VOLUME 2 OF 2 - ZONING

# Summary of Comments on P:\Projects\1216-00\BIM\Revit \Families\TITLEBLOCKS\EXTELL Proposal\_atwalj.pdf

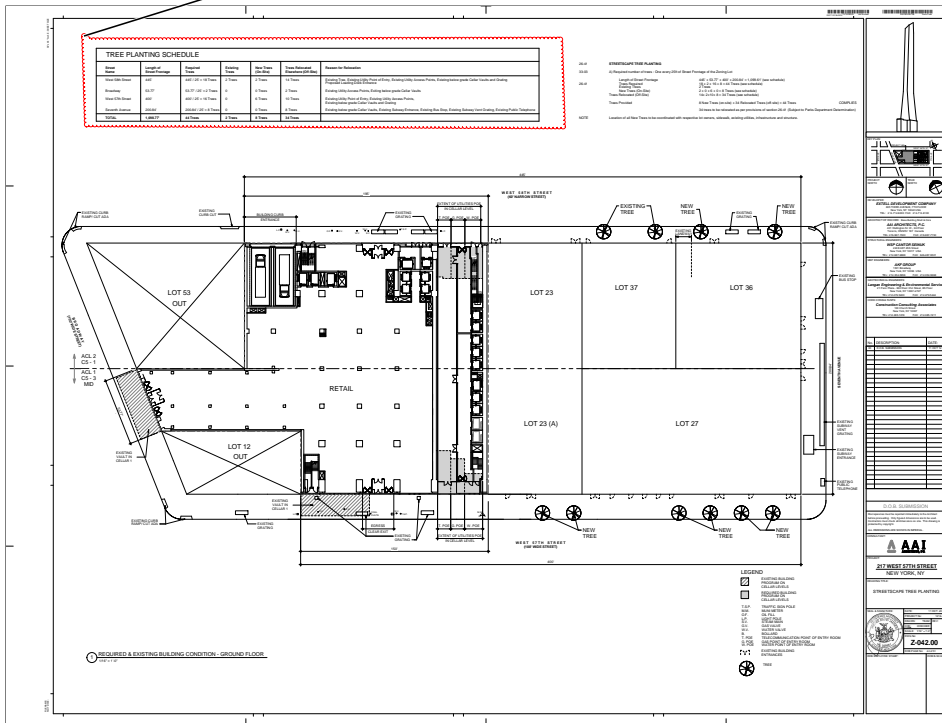
Author: dtitus Subject: Polygon Date: 1/8/2013 9:47:42 AM  
Please clarify deductions taken within stair inclosure. **TYP all floors.**  
8" for the stair perimeter, not sure what the additional 60+ sq. ft. is for per floor. ARCH/MH dwgs does not indicate any shaft enclosures within stair.

Author: dtitus Subject: Polygon Date: 1/8/2013 9:35:03 AM  
Mech. plan was not provided for this floor. 31st FL.

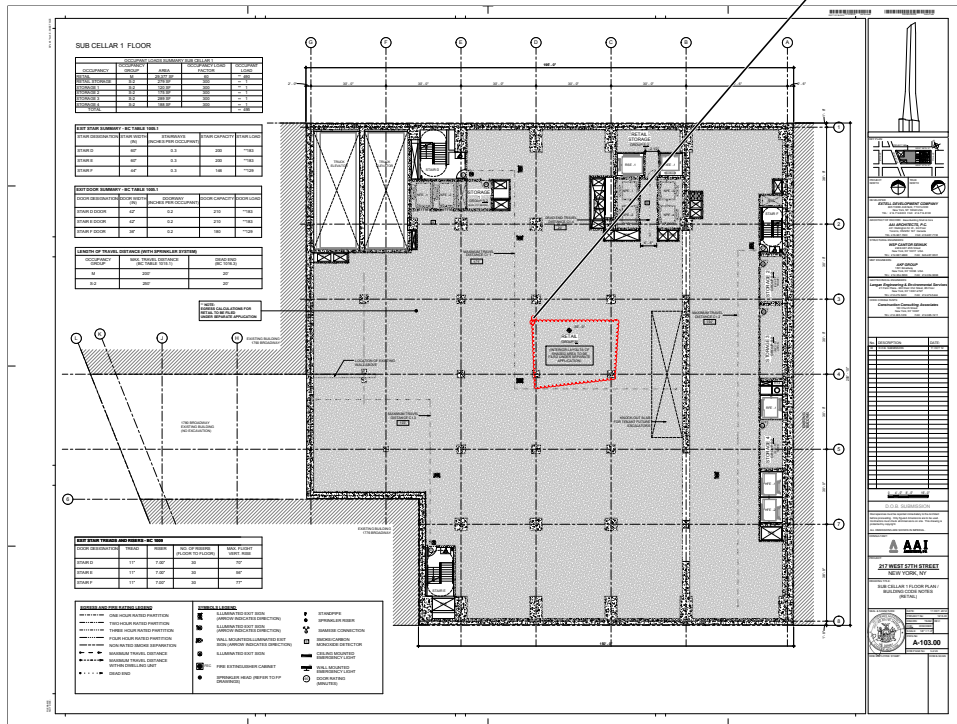
Author: dtitus Subject: Polygon Date: 1/2/2013 12:52:48 PM  
Provide curb cut details with plans and sections.

Location of proposed curb cut is contrary to section BC 406.7.6 (3). This is not a corner lot and a minimum separation of 8'-0" is required from side lot line.

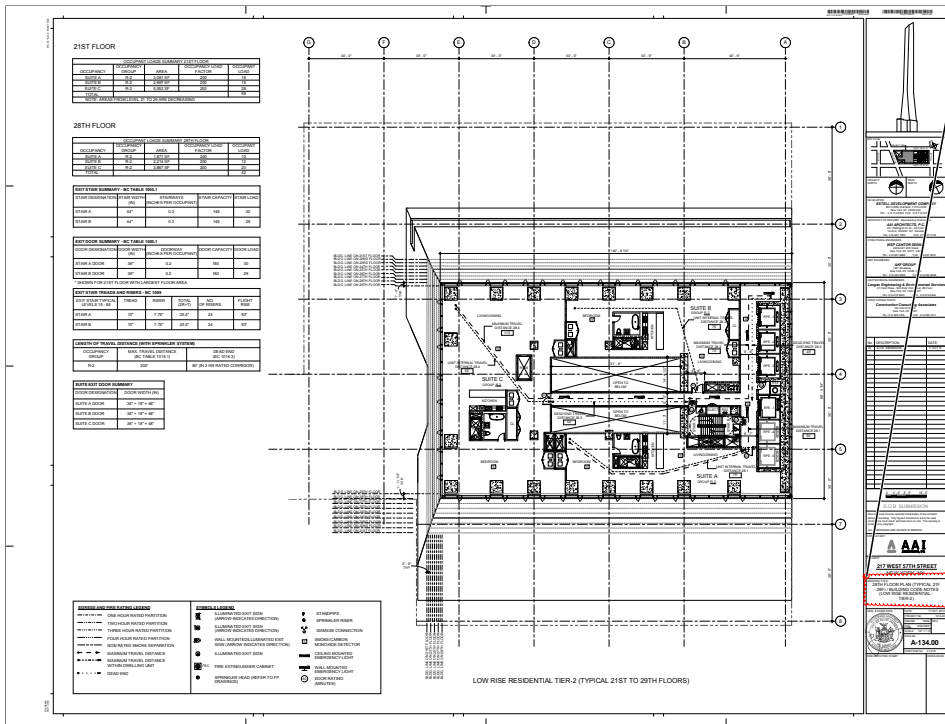
Group R-1 occupancies shall be provided with accessible features in accordance with Sections 1107.6.1.1 through 1107.6.1.3.

Show all grab-bars including vertical as per P102.8.3.1, (TYP)

Provide note within each accessible unit: unit or sleeping unit shall comply with the 2008 code and Chapter 1 through Chapter 10 of ICC A117.1.  
(TYP)

Author: dtitus Subject: Polygon Date: 1/7/2013 9:31:18 AM  
The common path of egress travel shall not exceed 125 feet as per BC 1013.3. The maximum length of exit access travel, measured from the most remote point within a story/space to the entrance to an exit along the natural and unobstructed path of egress travel, shall not exceed the distances given in BC Table 1015.1.

Author: dtitus Subject: Polygon Date: 1/7/2013 9:30:14 AM  
BC 908.7.1.2 Provide notes to indicate compliance for carbon monoxide detectors.  
Indicate location of smoke/ carbon monoxide detectors. (TYP.)

Author: dtitus Subject: Polygon Date: 1/4/2013 10:06:27 AM  
Provide refuse chute details: [2 hr fr walls & roof] and compliance with BC 1213.3 and BC 707.13  
Refuse storage room to comply with BC 1213.1  
Provide proper enclosure and details  
Provide UL # for system or fire hopper doors  
Compliance with BC 1101.2;

Author: dtitus Subject: Polygon Date: 1/4/2013 10:41:39 AM  
Provide note describing stairway door operation and stairway communications system as per BC 403.12  
Provide note describing smoke proof exit enclosures for compliance with BC 403.13.  
Provide note describing impact-resistant stairs enclosures as per BC 403.15  
Provide exit lighting and directional signs (lighting) & (egress) as per BC 1006, BC 1011, BC 1026 (both EG and Construction plans)

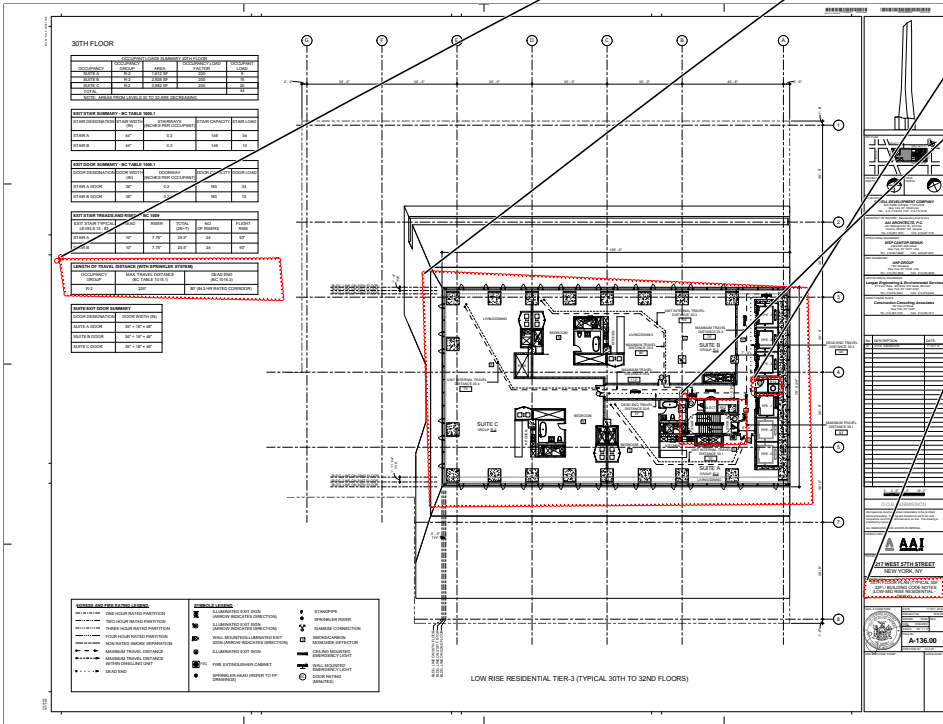
Author: dtitus Subject: Polygon Date: 1/4/2013 10:05:14 AM  
Please indicate as Typ. 30-32nd Floor Plans

BC 1101.1, 1101.2, and  
ICC/ANSI A117.1-2003 Verify compliance with accessibility as per BC 1101  
Primary access- 1105  
Doors & maneuvering clearances-1107.2.1  
Residential bathrooms – 1107/ Appendix P  
Residential kitchens – 1107.  
Show all grab-bars including vertical as per P102.8.3.1,  
Walk-in closets  
Access to W/D within units  
**TYP. all R-2 floors**
